Contract No.: DL00353

Proposed Replacement of Bridge 254 on SR 1512

RE: Addendum #1 to Contract DL00353

PRESTRESSED CONCRETE CORED SLAB DETAILS

REVISIONS SHEET NO S-11 DATE: NO. BY: DATE: BY: TOTAL SHEETS ALP 07/10/2025

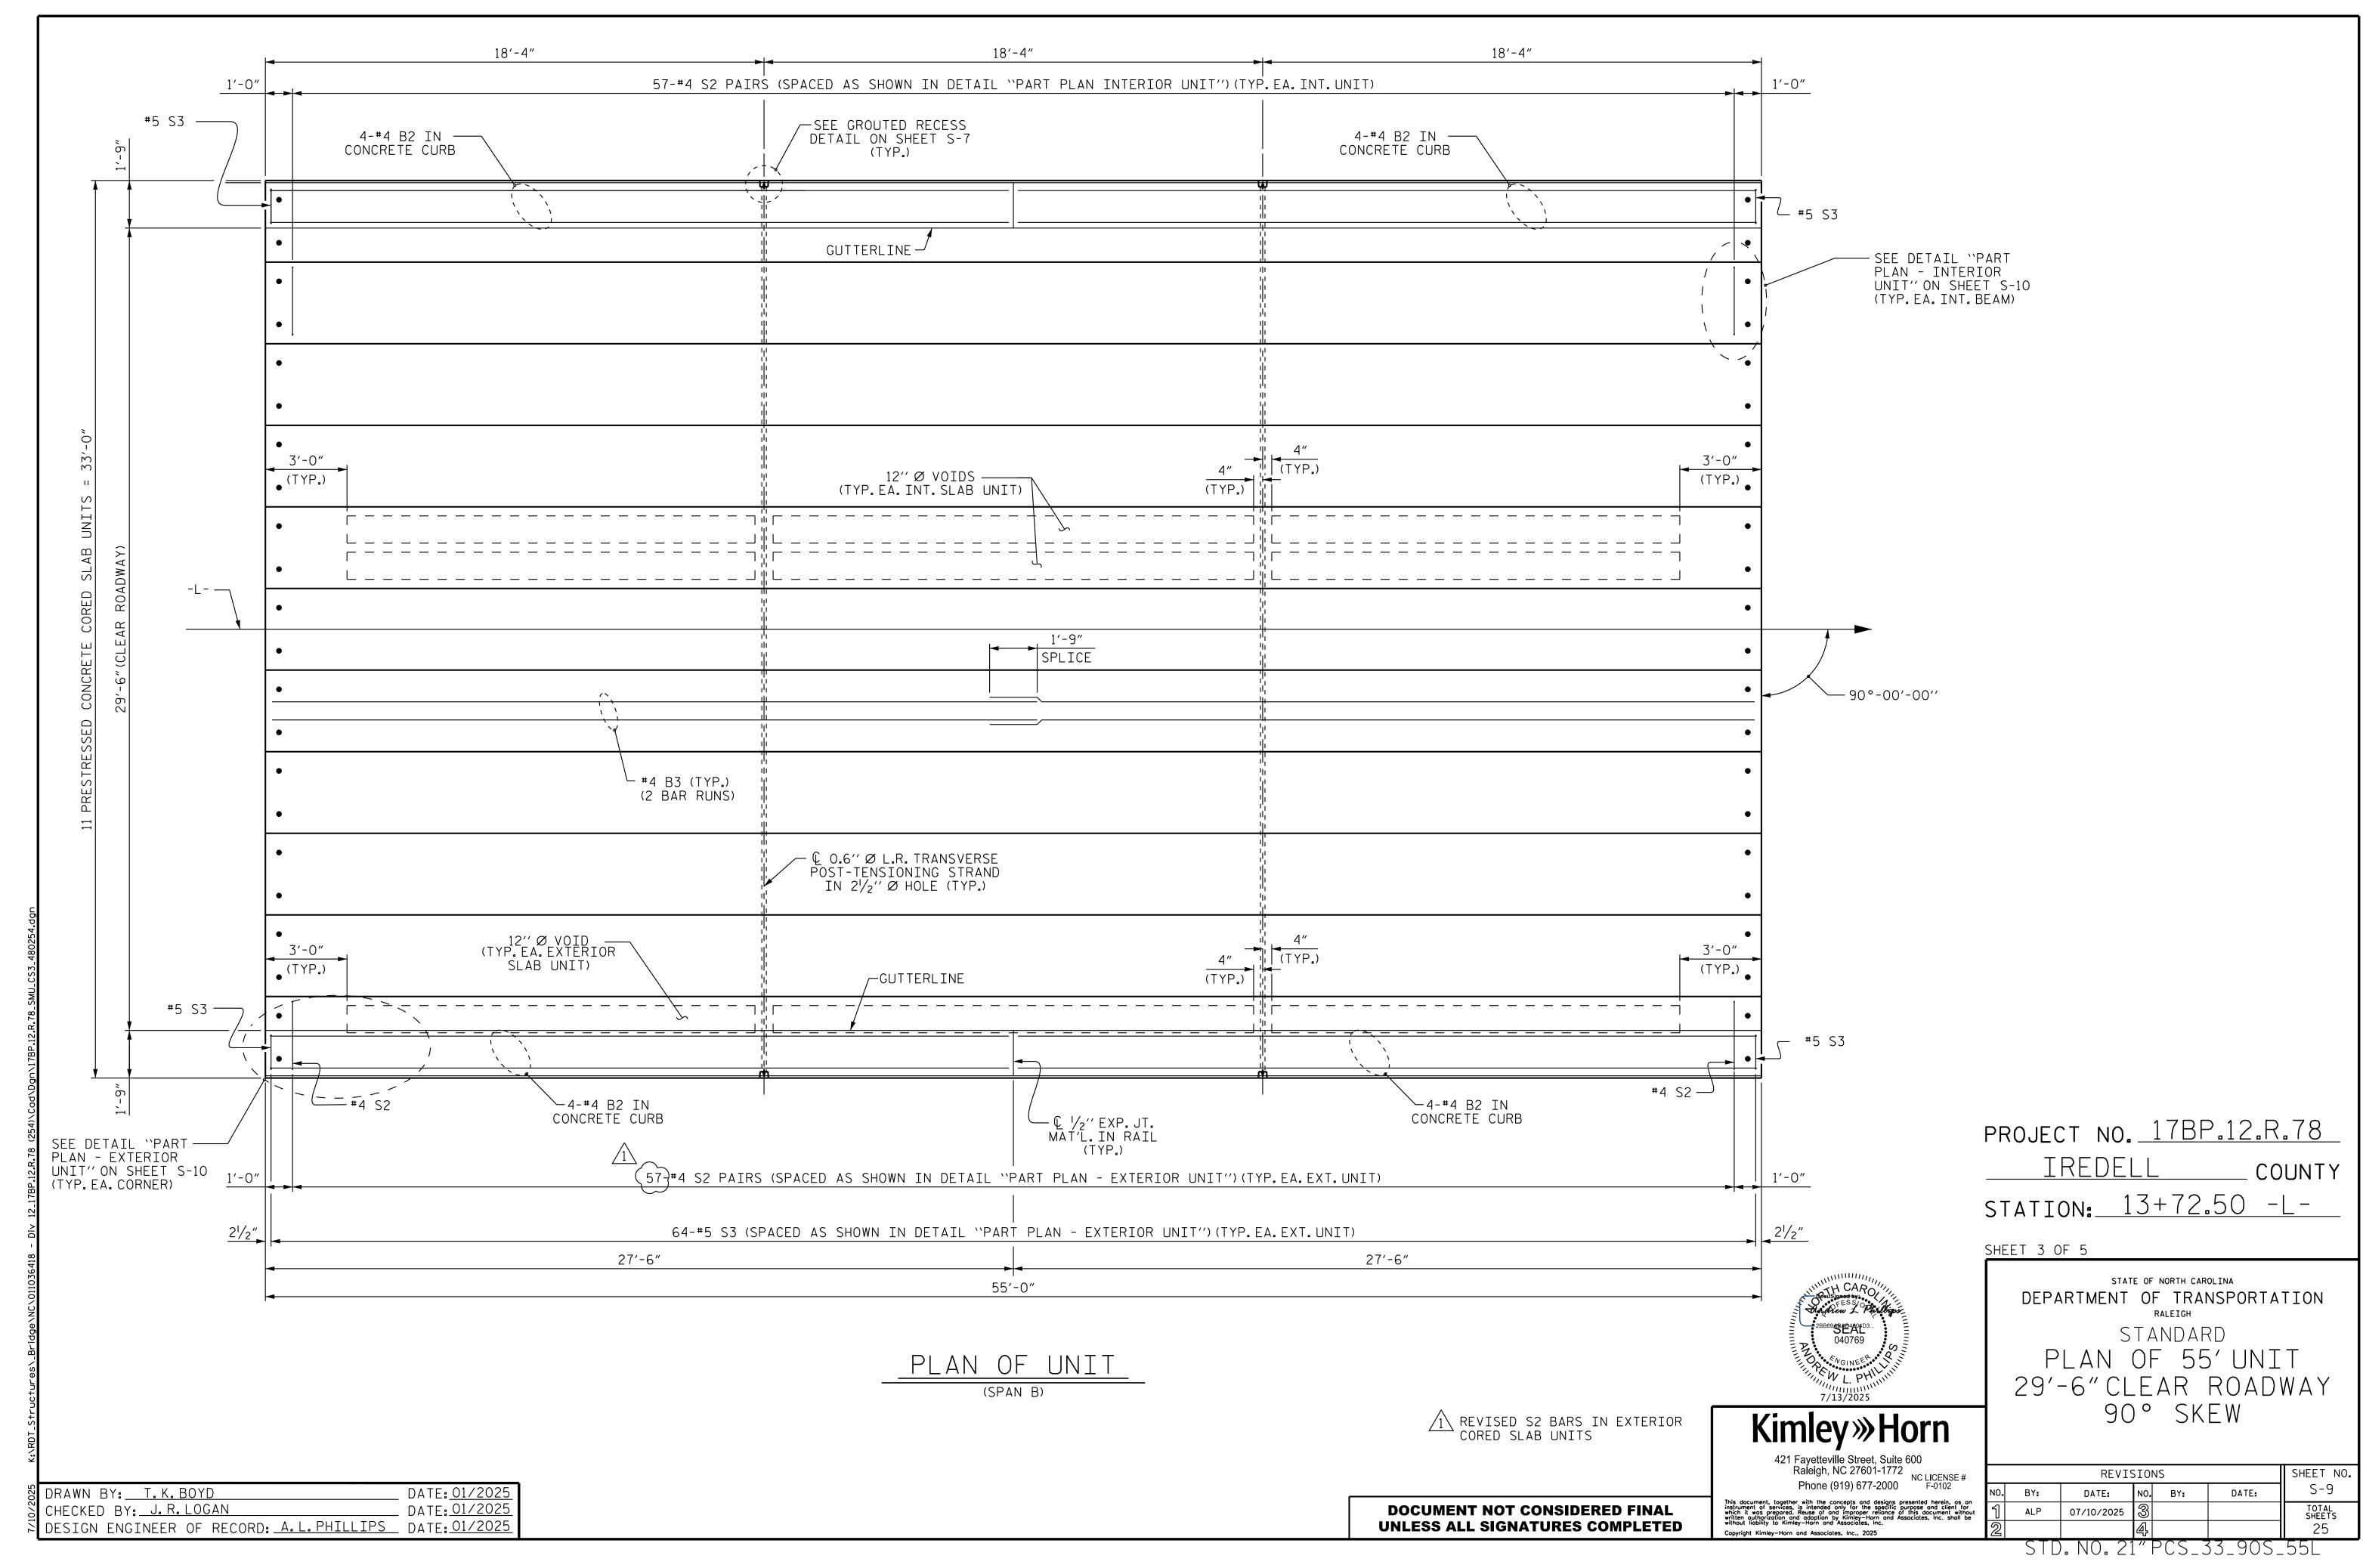
/1\ REVISED S2 BARS AND CONCRETE IN EXTERIOR CORED SLAB UNITS
